COUNCIL ASSESSMENT REPORT

Panel Reference	PPSSNH-435
DA Number	LDA2023/0245
LGA	City of Ryde
Proposed Development	Stage 2 detailed design of the land-based portion of the site in accordance with LDA2018/0223, including tree removal on the site, construction of commercial and residential premises, including 18x3 storey townhouses and 2x3 storey RFB and adaptive reuse of the boatshed building to contain 19 dwellings (67 residential units across the site) and four commercial/retail tenancies, basement car parking and associated landscaping work.
Street Address	20 Waterview Street, Putney (Lot 1, DP 430647, Lot 1, DP 70489, Lot 2, DP 70488 and Lots 440–447, DP 15224)
Applicant/Owner	Applicant: Perifa Owner: PMAP Putney P/L
Date of DA lodgement	29 September 2023
Total number of unique submissions	First notification/advertising period: Three (3) submissions objecting to the development Second notification/advertising period: Nine (9) submissions objecting to the development

Figure 9 – Building height plane diagram showing the elements of the residential flat buildings which exceed the height limit (green represents the 9.5m height control, orange represents the 14m height control and green represents the 11.5m height control)

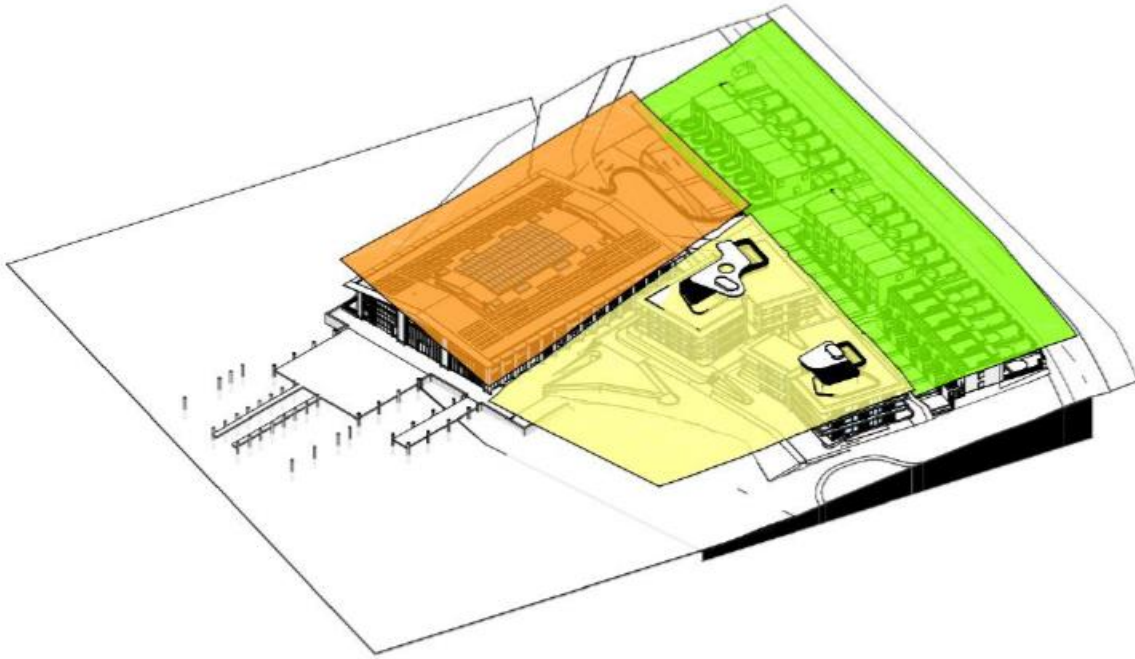
Under the provisions of Clause 4.3 of the Ryde Local Environmental Plan 2014, the subject site is mapped as having a maximum permitted building heights of 14 metres, 11.5 metres and 9.5 metres. The proposal complies with the 14 metre and 9.5 metre height limits, however a variation is proposed in relation to the residential flat buildings and the 11.5 metre height limit.

Component	Approved Height in LDA2018/0223	Proposed Height	LEP Maximum Height	Proposed Variation
Residential Flat Building (East)				
Parapet	RL16.15	RL16.35	RL16.35	Compliant
Lift Overrun	RL19.35	RL19.35	RL16.93 to RL17.13	2.22m to 2.42m variation or 12% to 14%.
Pergola	RL18.36	RL18.75	RL16.89 to RL17.45	1.3m to 1.86m variation or 7% to 11%.
Car Park Exhaust	-	RL18.75	RL16.82 to RL16.92	1.83m to 1.93m variation or 10% to 11%.
Residential Flat Building (West)				
Parapet	RL16.15	RL16.35	RL16.22	0.13m variation or 0.8%.
Lift Overrun	RL19.35	RL19.35	RL16.98 to RL17.04	2.31m to 2.37m variation or 13%.
Stair Overrun	RL19.35	RL18.75	RL17.00	1.75m variation or 10%.
Pergola	RL18.36	RL18.75	RL16.70 to RL17.35	1.4m to 2.05m variation or 8% to 12%.

As shown in the table above, the application results in reduced heights (compared to the Stage 1 consent) relating to some elements of the buildings and increased heights in other building elements. Critically, it is noted that the maximum building heights of RL19.35 for both buildings, approved in the Stage 1 application are not sought to be increased in the subject modification application. **Figure 9** is a building height plane diagram which visually depicts the components of the buildings not complying.

Assessment Officer's Comments: The applicant has identified sufficient environmental planning grounds to vary the building height standard. The site has an uneven topography which falls from east to west towards the waterfront. This gives rise to an irregular height plane across the site which results in the proposed residential flat buildings partially breaching the height plane as they fall across the site, in turn causing a technical non-compliance with the Height of Buildings development standard.

Figure 11 – Extract of ground floor plan showing primary pedestrian entry to the site

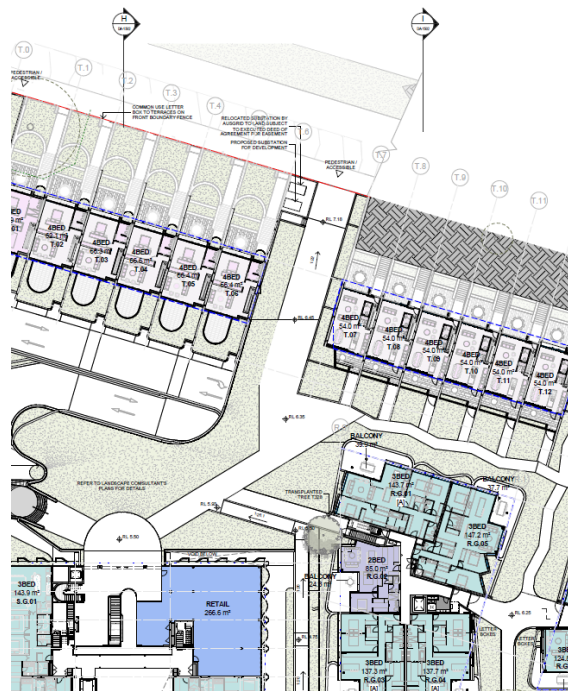
- **Pedestrian Access.** *It is suggested that the main pedestrian access be widened and have it from front boundary to the Halverson Shed not in a Maze like Fashion. The community want to enjoy this and the businesses need to thrive.*

Comment: The application was amended during the assessment phase to widen the central pedestrian entrance to the site from Waterview Street. There is a separation of 12.665 metres between Townhouse 6 and Townhouse 7 which will provide a direct line of sight from Waterview Street to the Boat Shed building where the retail/commercial tenancies are located (**Figure 11**).
